Lakeside Farms Elementary – ESS Relocatable

Bid #: 2024-03C

Lakeside Union Elementary School District

ADDENDUM 01

C-1.0

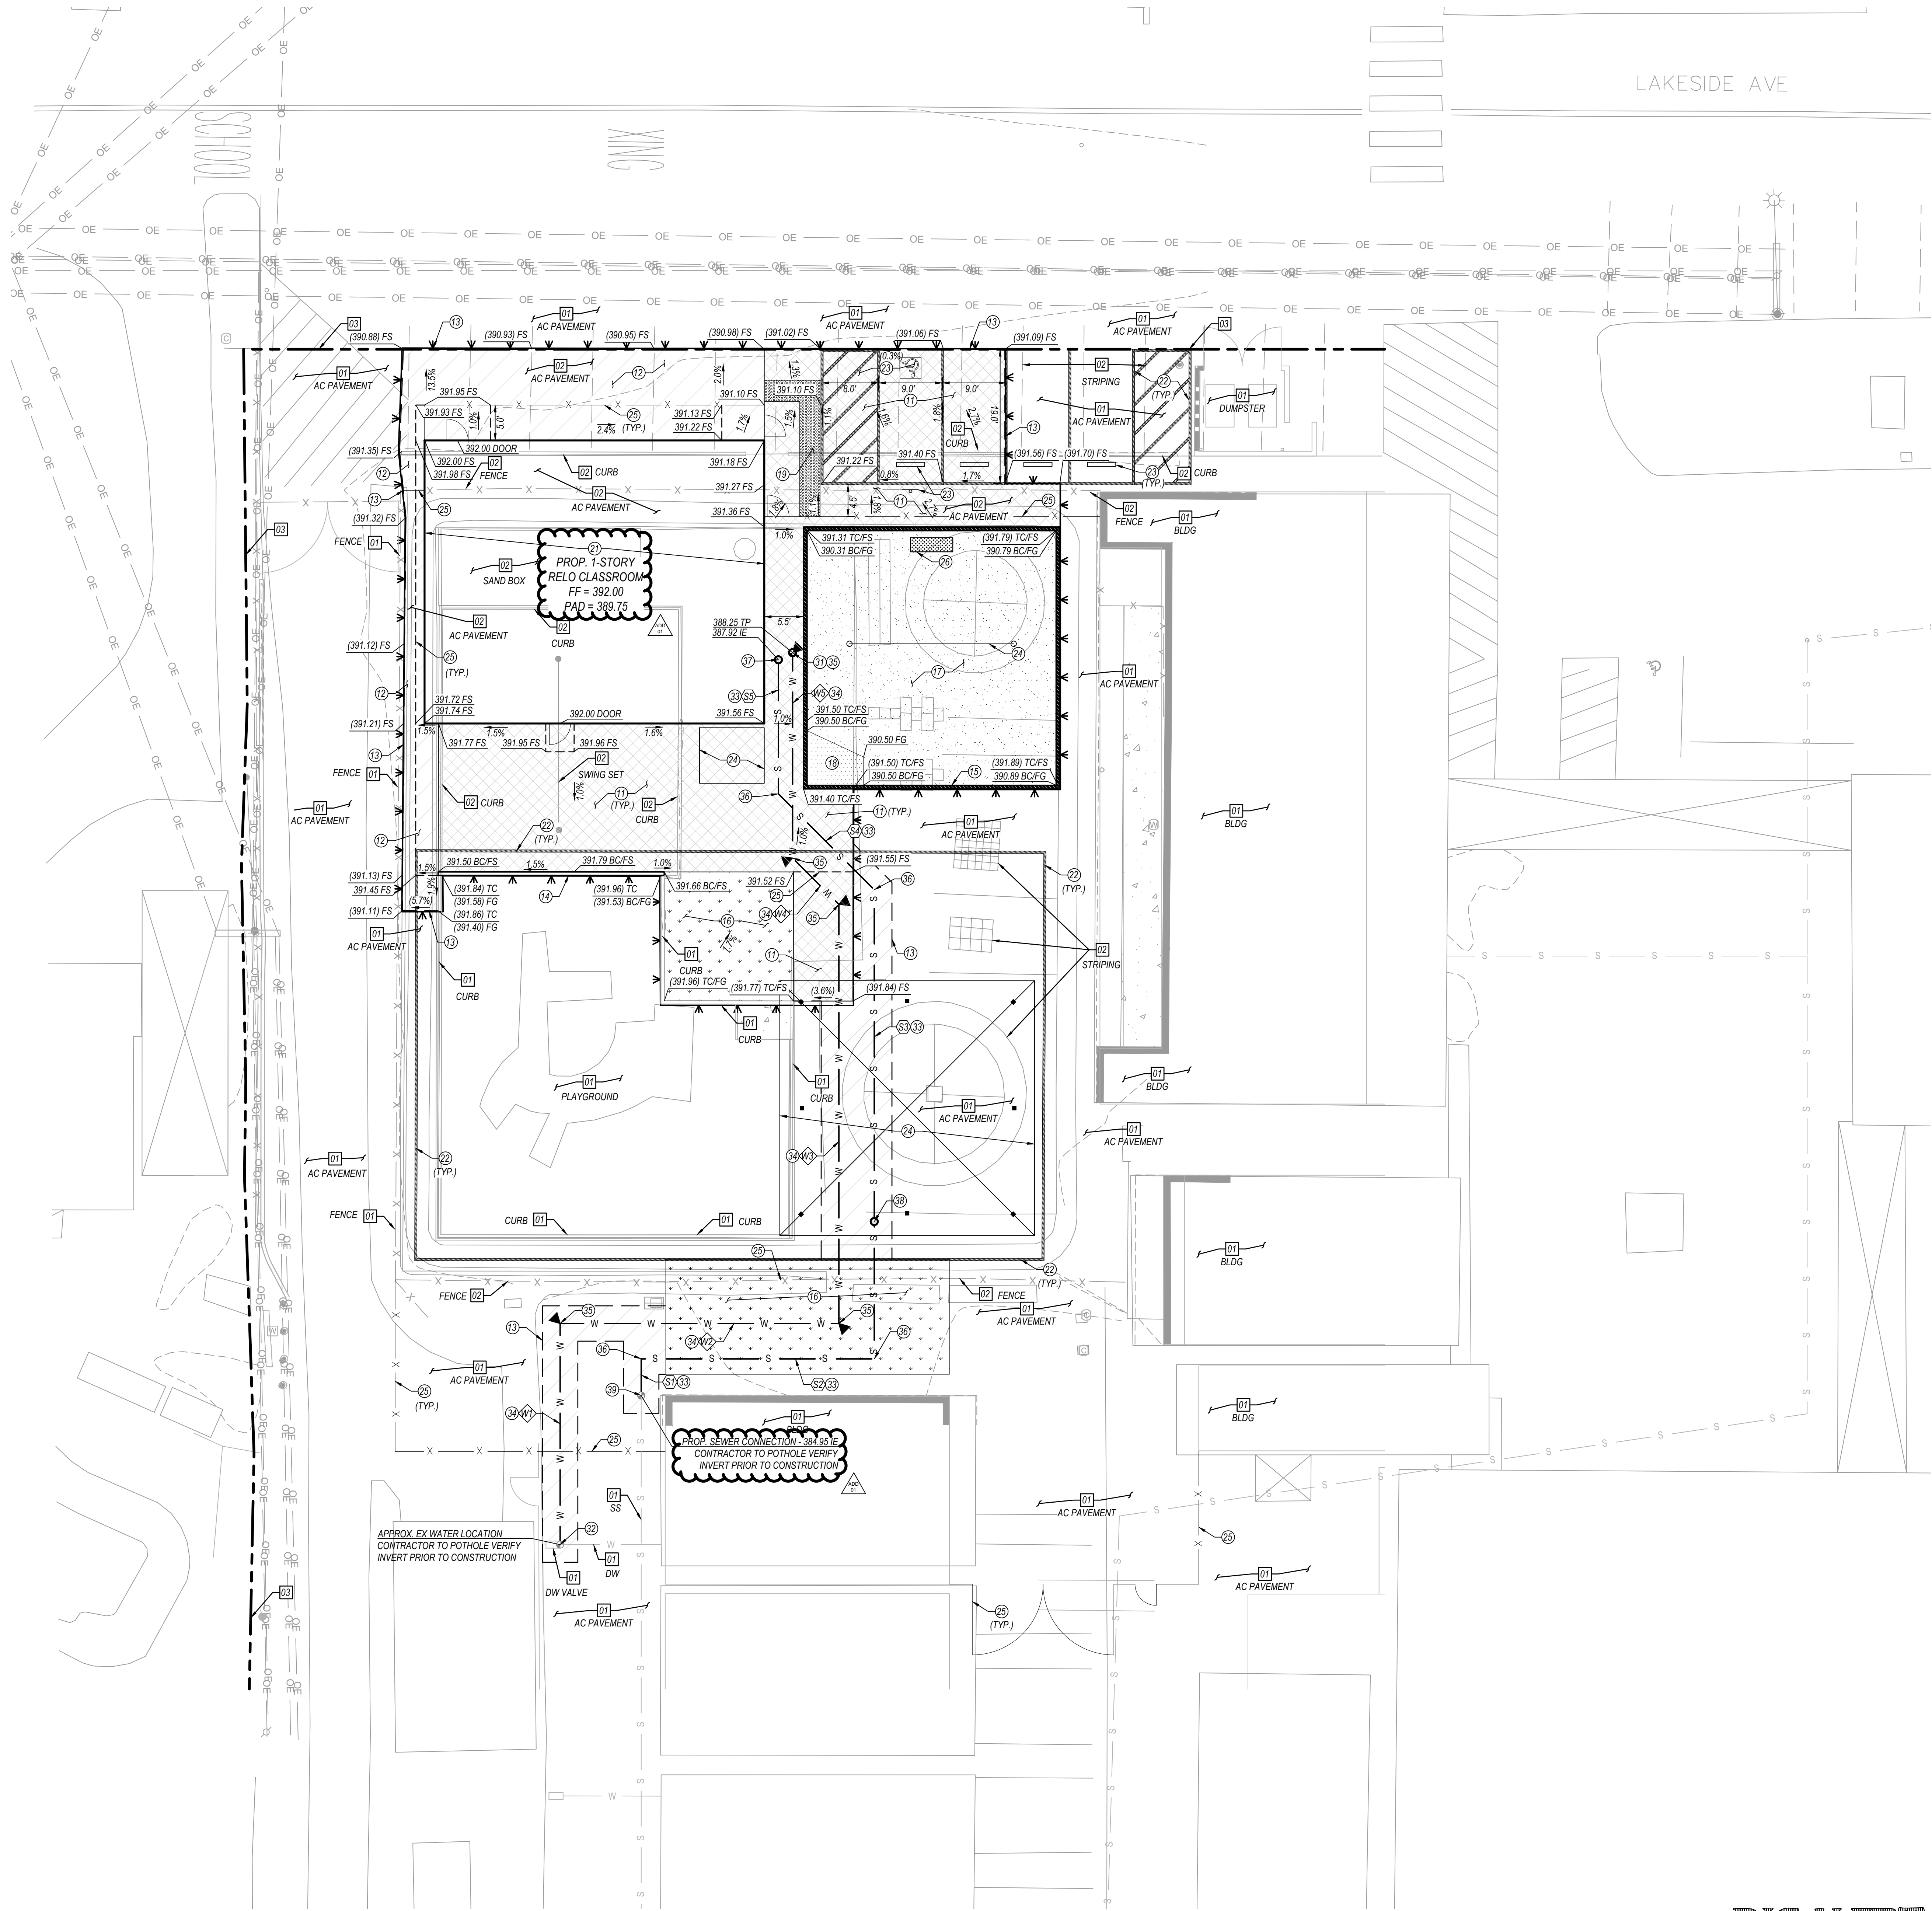
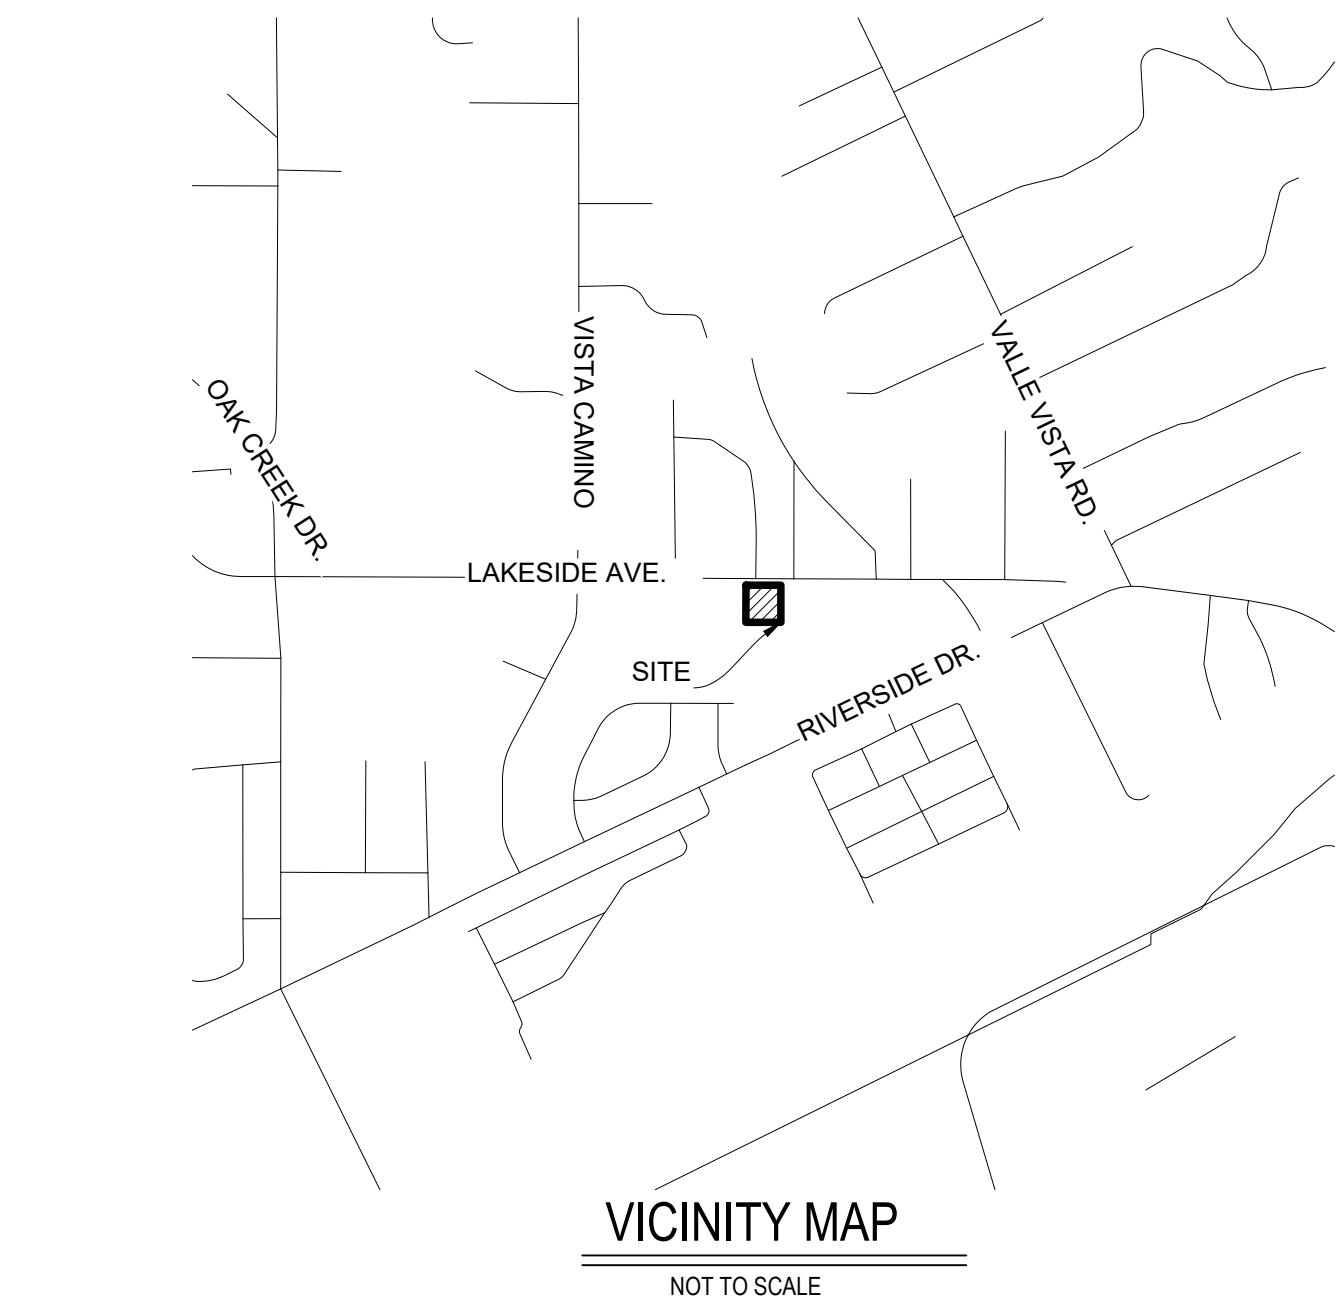
- Item #1. REVISION – Title Sheet C-01
 - a. Revised survey benchmark and basis of bearings information.
 - b. Revised earthwork totals for cut/fill/net export yardage from pad grade change.

- c. Revised construction notes, symbols, and quantity totals for legend.
- Item #2. REVISION – Grading and Utility Plan C-02
 - a. Revised pad grade information to match structural plans.

C-2.0

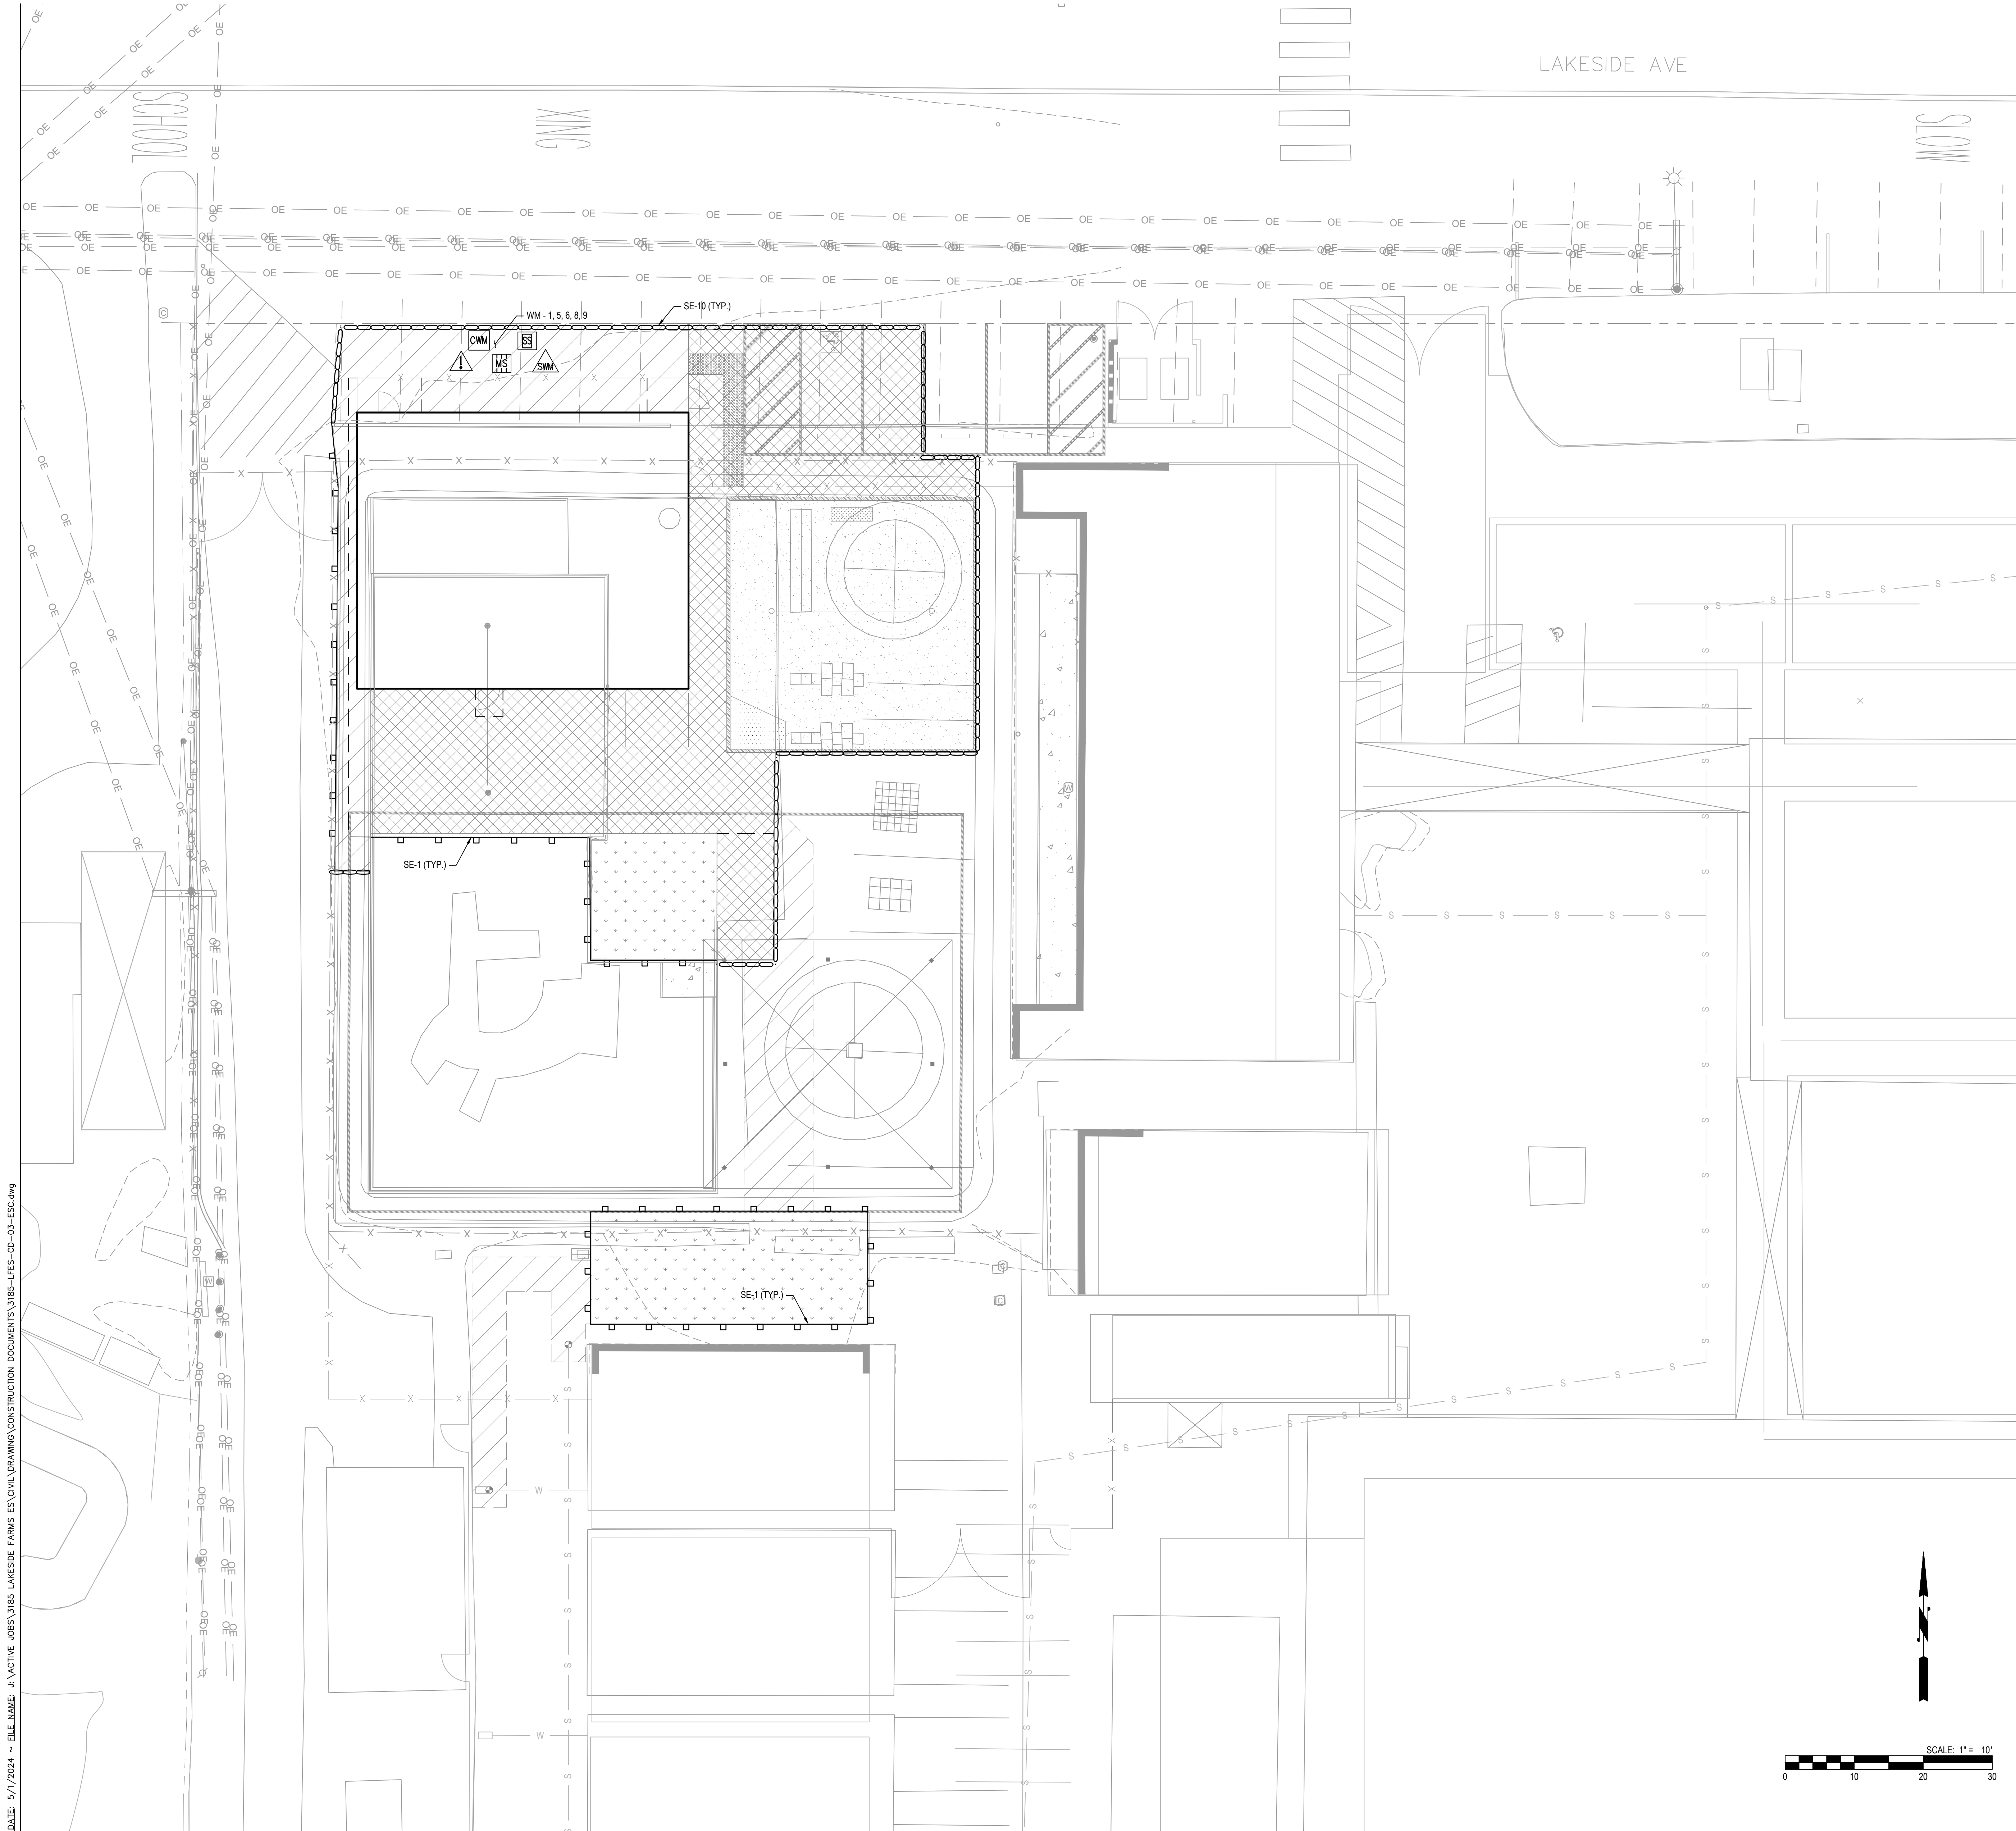
- b. Revised sewer lateral invert elevations and point of connection note.
 - c. Revised construction notes, symbols, and legend.
 - d. Revised data tables for domestic water and sewer laterals.
